TO : All Bidders
FROM : El Monte Union High School District
BID # : 2024-25 (B5)
PROJECT : Rosemead Adult Education and Transition Center Addition/Modernization REBID
SUBJECT : Addendum No. 2

ADDENDUM 04

Rosemead Adult Education and Transition Center

DSA Application No: 03-122743

54 PLANTER BOX DETAILS
SCALE: 1" = 1'-0"

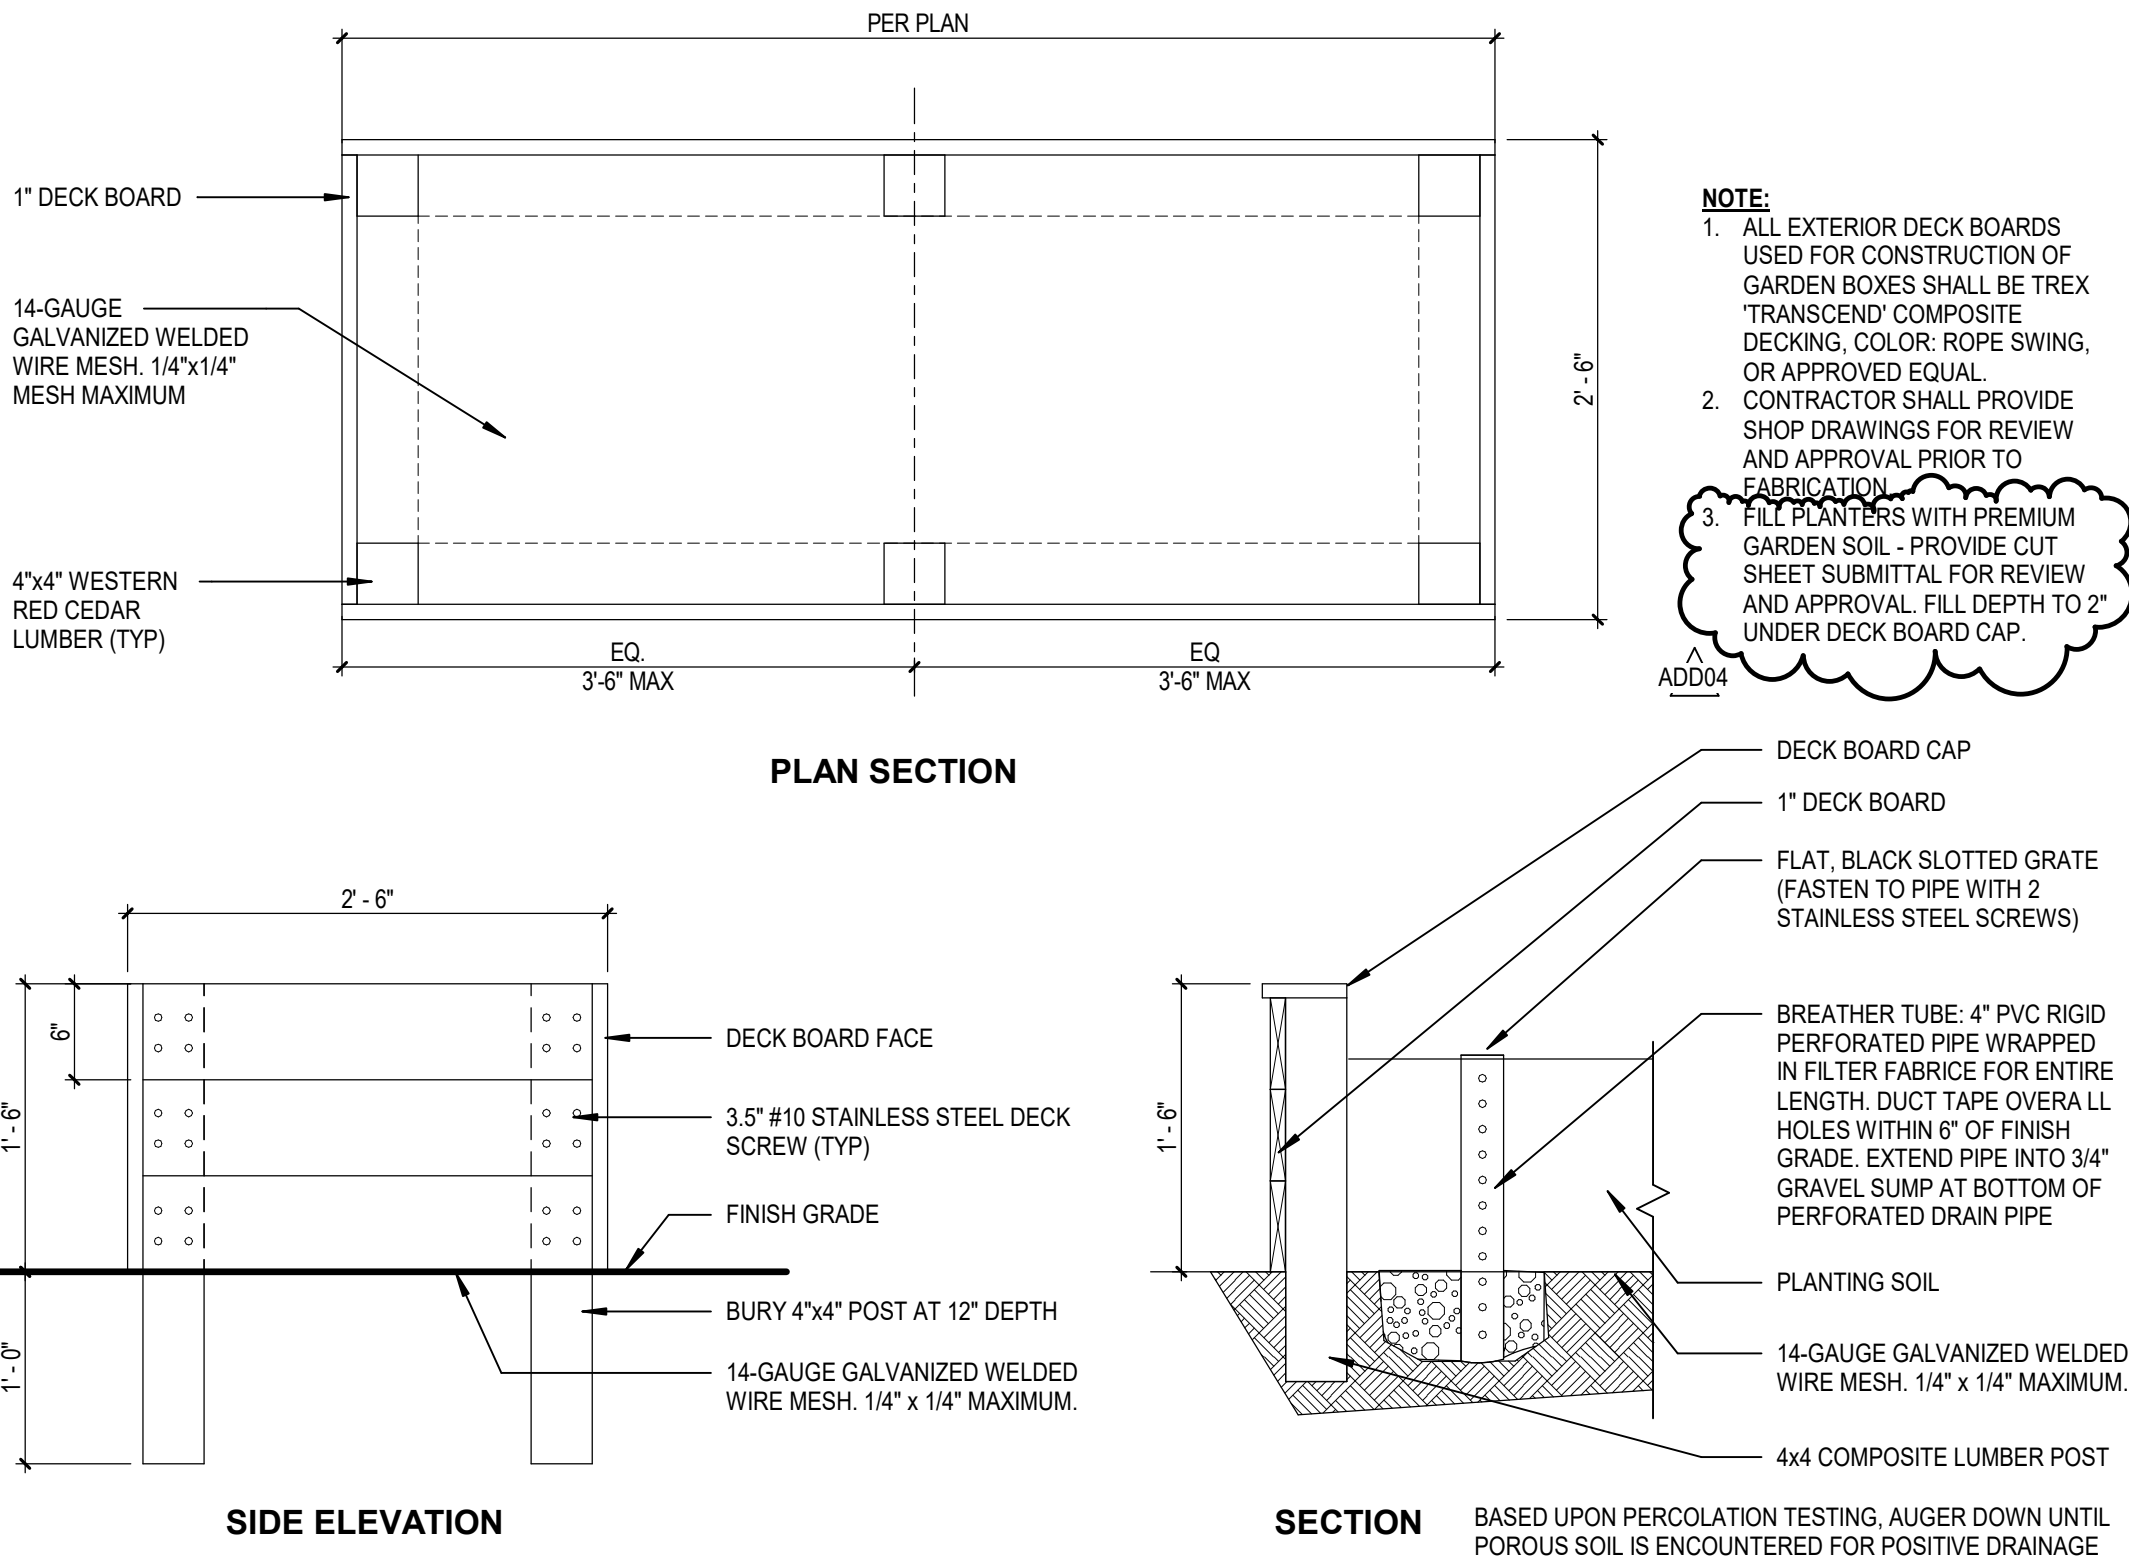
RFI 150..... Regarding the planters at the courtyard shown on G2.2, detail 54/A0.4 does not show any information regarding the depth and type of soil required. Please clarify.

A. *Added Note 3 in Detail 54/A0.4.*

Answer.....*Fill planters with premium garden soil – provide cut sheet submittal for review and approval. Fill depth to 2" under deck board cap.*

5 WALL SECTION - SEISMIC JOINT
A6.1 SCALE: 3/4" = 1'-0"

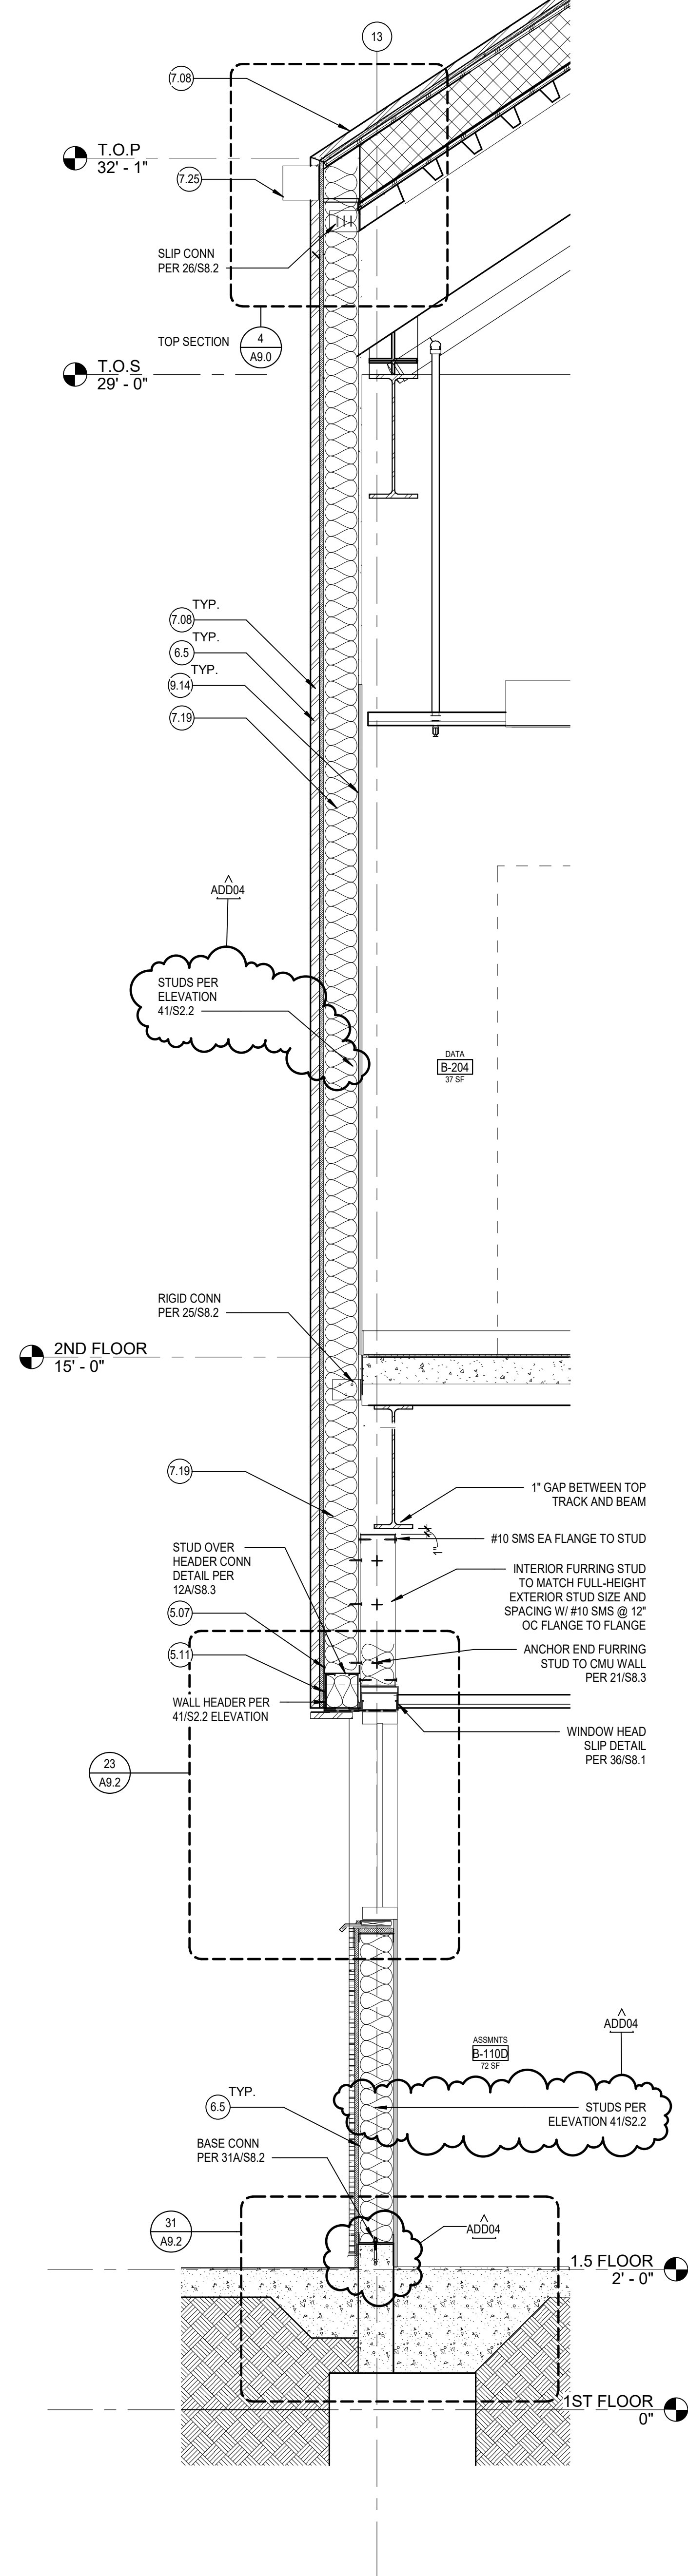
RFI 166 Please reference 5/A6.1 which occurs along grid lines 8 & 8.1, between grid lines A-B. The wall along grid line 8 is existing, and indicates exterior lath & plaster full-height as shown. Since this wall is existing and this is where the first floor demolition will start per A1.0 (no demolition at second floor this area), it's assumed that the lath & plaster is existing above the existing first floor building area and that horizontal plaster patching will be required only where the existing first floor roof line will be removed.

It's also assumed that the remainder of the existing plaster above will remain and be painted only per wall type X-0, per 6/A9.0. Are our assumptions correct? Please clarify and provide an elevation or details as needed

Answer.....*The existing lath and plaster above the first-floor roof line can remain, provided that the final finish of this concealed wall is a complete and watertight system. The final plaster that will be concealed does not need to be painted.*

51 SECTION DETAIL - OFFSET WALL
A9.1 SCALE: 1 1/2" = 1'-0"

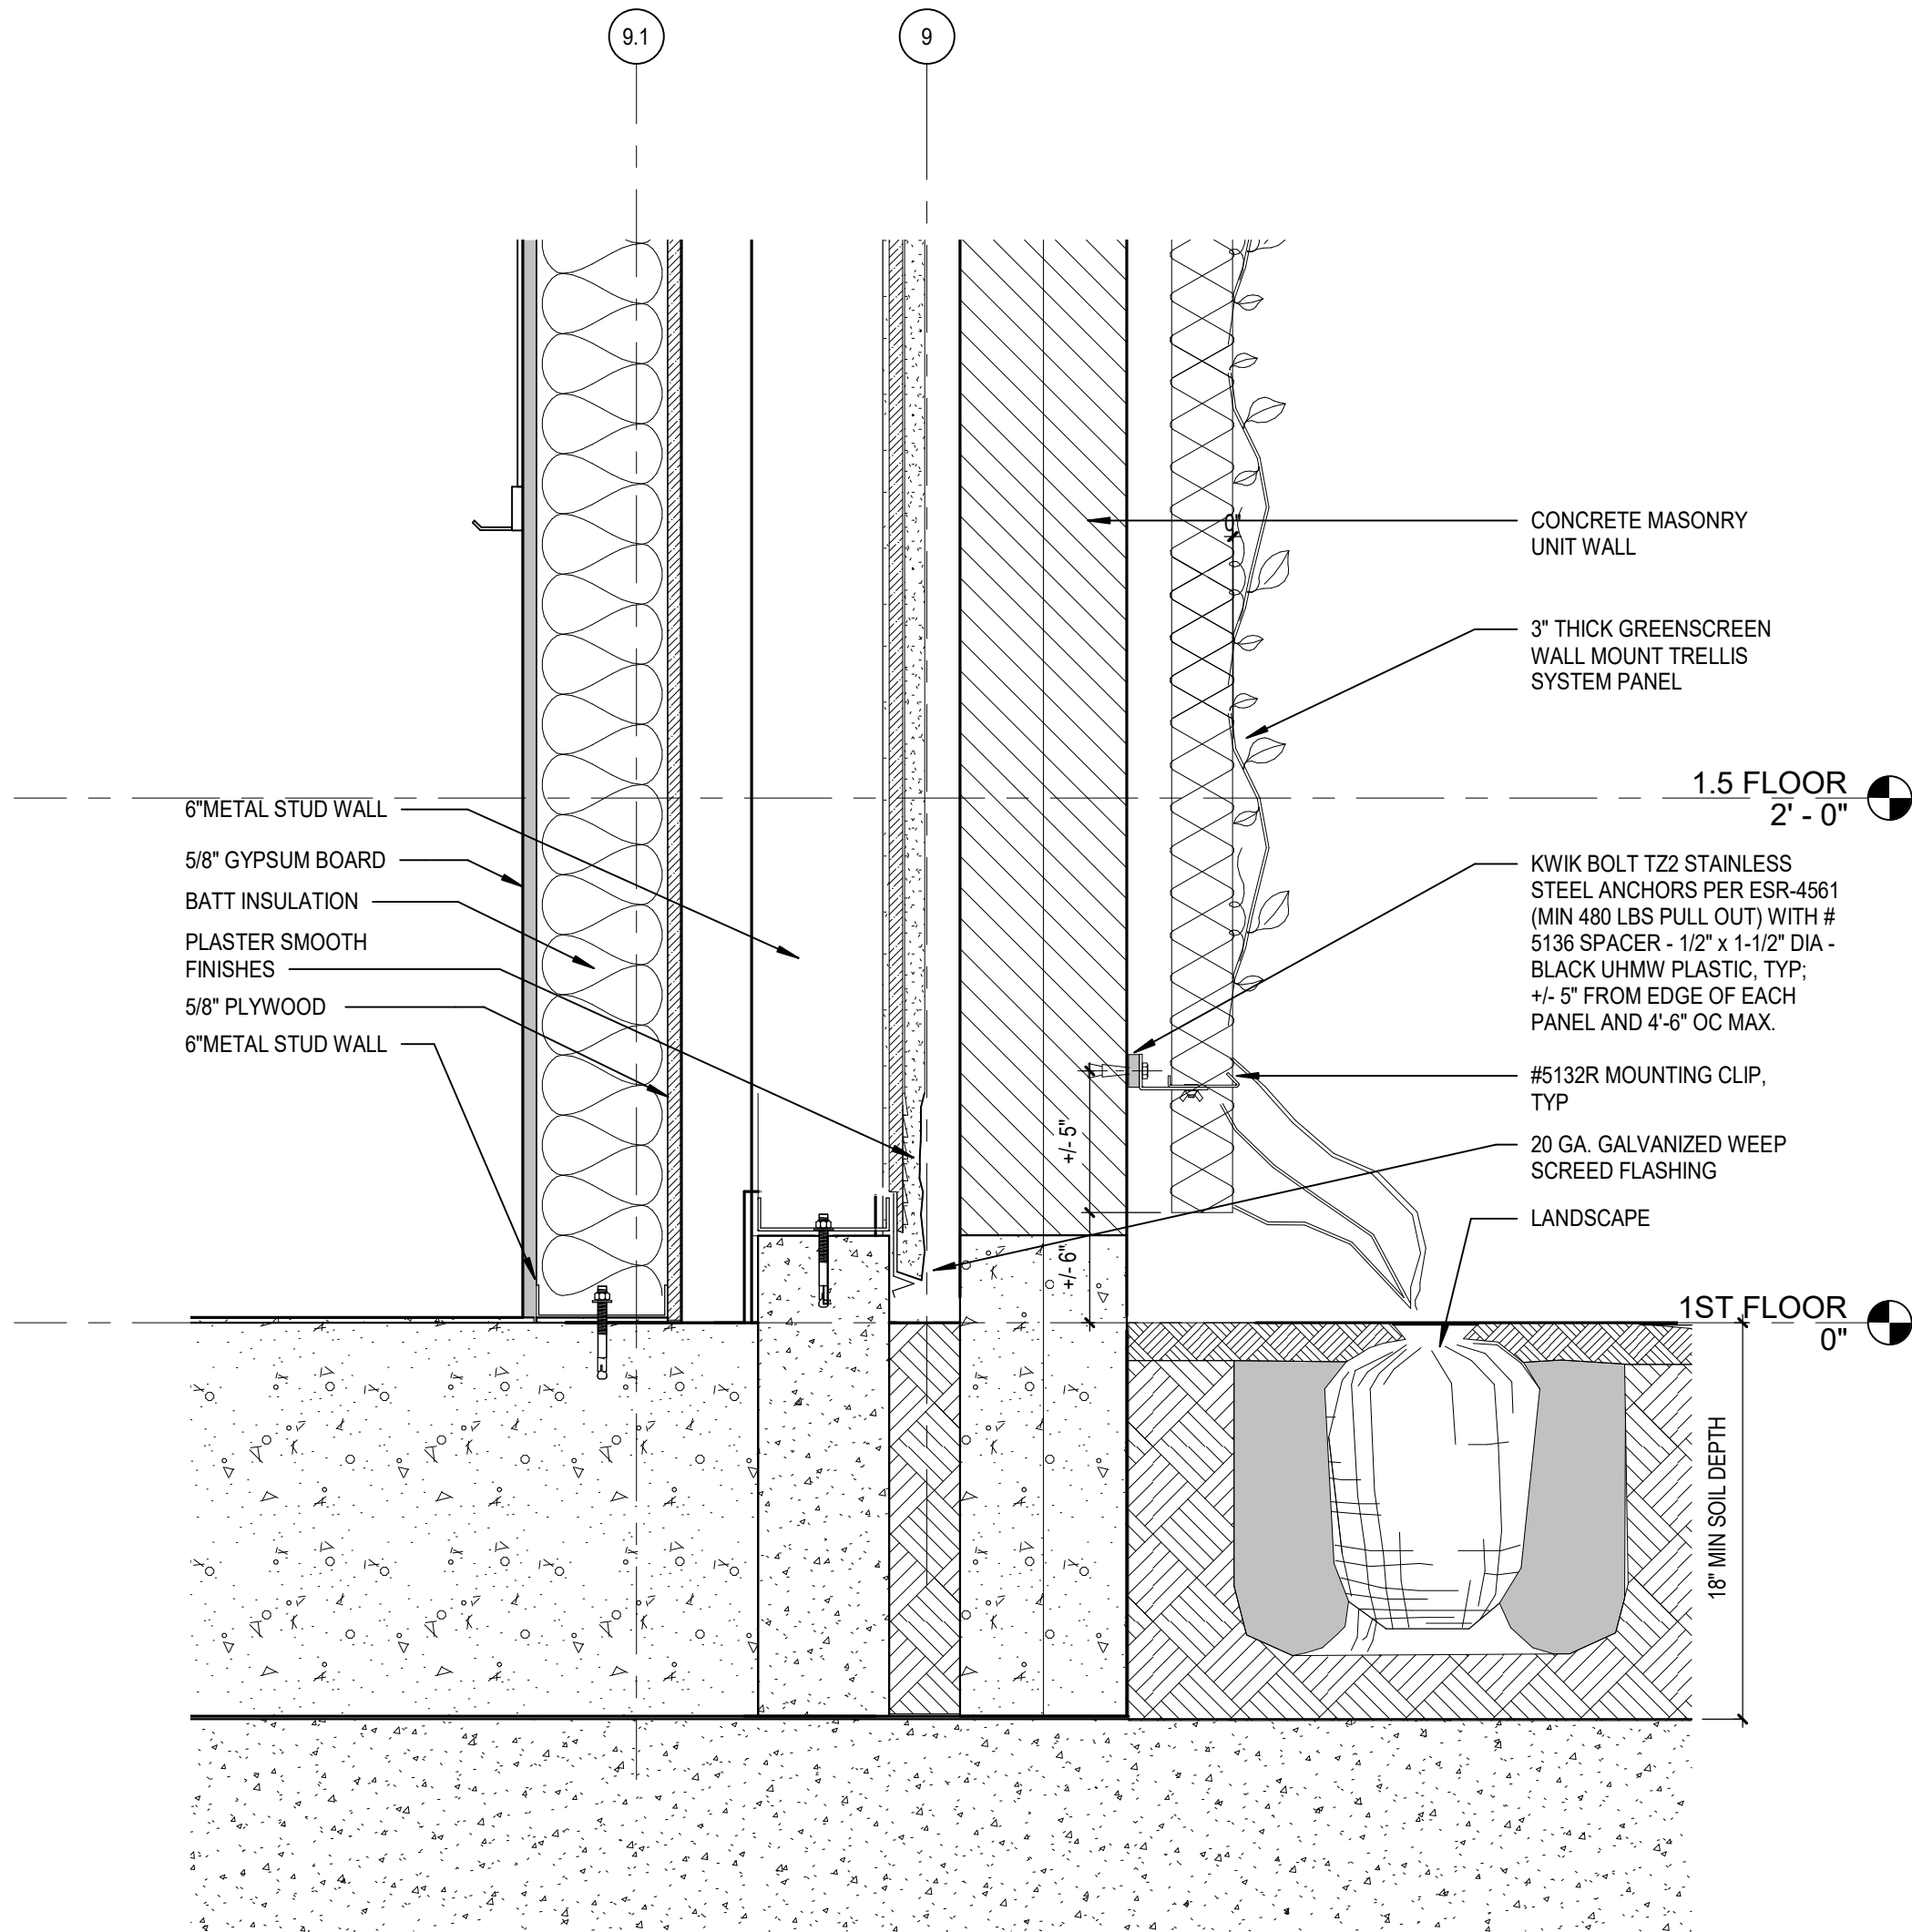
A. Detail 51 updated to provide clarity for structural connections, member sizes, and drift joint locations.

55 ELEVATOR SHAFT WALL TRANSITION TO PIT
A10.03 SCALE: 1 1/2" = 1'-0"

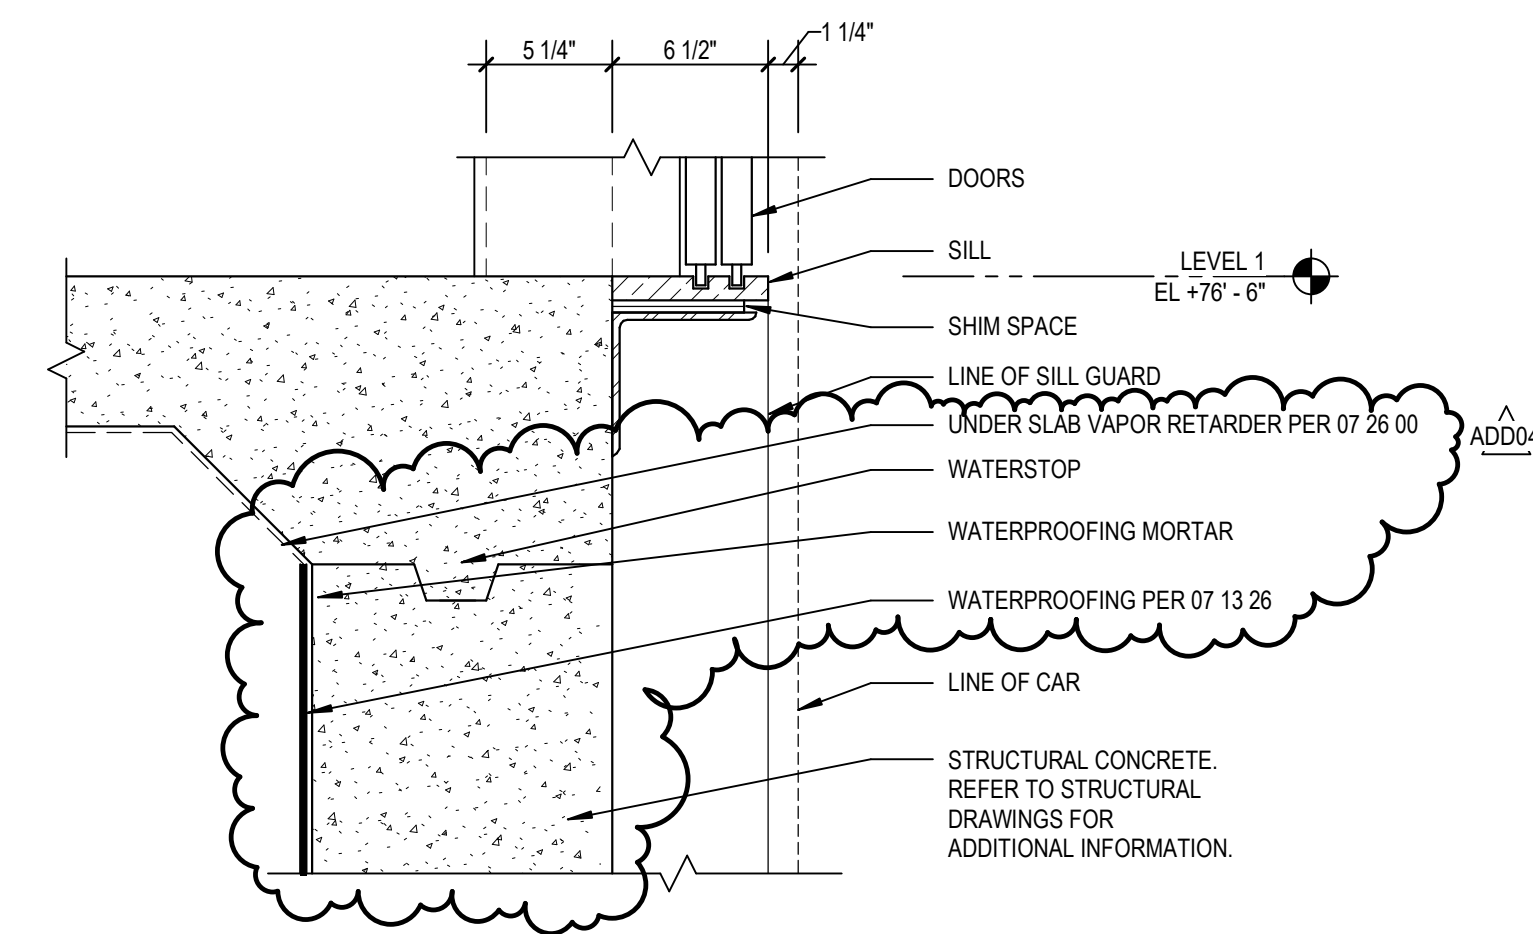
RFI 152..... On drawing A10.03, detail 55 shows waterproofing and references sheet A5.1.2. This sheet was not found in the plan set. Please clarify.

RFI 153..... Please clarify if the elevator pit waterproofing shown on 55/A10.03 applies to spec section 071326. Will only the interior of the elevator pit require waterproofing?

A. Revised detail 51/ & 55/A10.03.

Answer.....*Refer to revised detail.*

Answer.....*Confirmed. Refer to revised detail.*
